1 BUILDING 5 - WINDOW DEMOLITION PLAN
AE103 SCALE: 1/16" = 1'-0"

2 BUILDING 5 - WINDOW REPLACEMENT PLAN
AE103 SCALE: 1/16" = 1'-0"

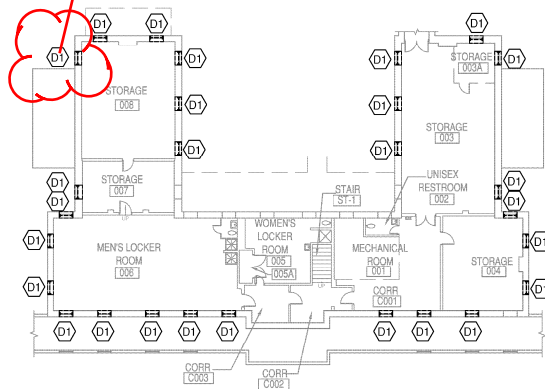
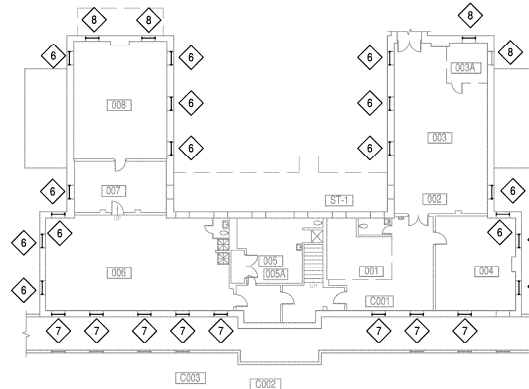
There is no window at this location it is a brick infill, is the brick to be removed for the new window or will this new window be deleted?
